From: [Debra M. Beckwith](#)
To: [BROffice](#)
Subject: Bridge Advertisement (DSI 20-037) Slab Drain on steel Std Dwg note
Date: Wednesday, September 23, 2020 3:08:56 PM
Attachments: [image001.png](#)
[image002.png](#)

Implementation Statement: Applies to jobs not thru Review

Screen shots of S_DRA03 (S_DRA10 similar except for guidance note number):

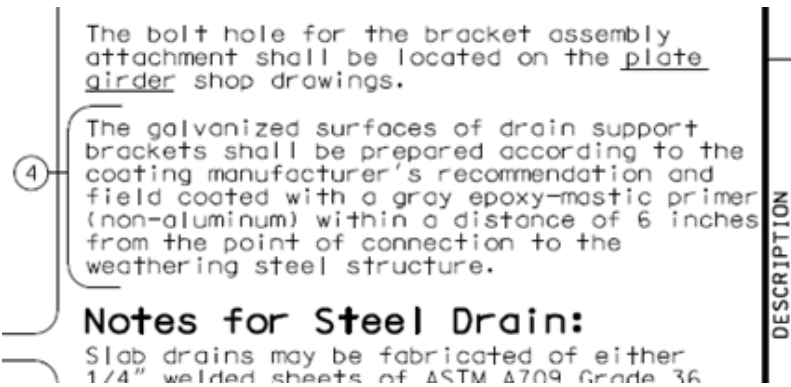
Revision Date	Items Revised	Description of Change
Sept. 2020	EPG: 751.50	Added note H7.8.2 in EPG and on bridge std dwgs requiring epoxy-mastic primer on galvanized drain support brackets when attached to weathering steel girders/beams. (H7.8.2) Use note when attaching to weathering steel girders and beams. The galvanized surfaces of drain support brackets shall be prepared according to the coating manufacturer's recommendation and field coated with a gray epoxy-mastic primer (non-aluminum) within a distance of 6 inches from the point of connection to the weathering steel structure.
	Bridge Standard Drawings: S_DRA03 , S_DRA10	
	MicroStation Cells: NA	
	Std. Specifications: NA	
	Standard Plans: NA

④ Use with weathering steel. Delete for painted or galvanized steel.
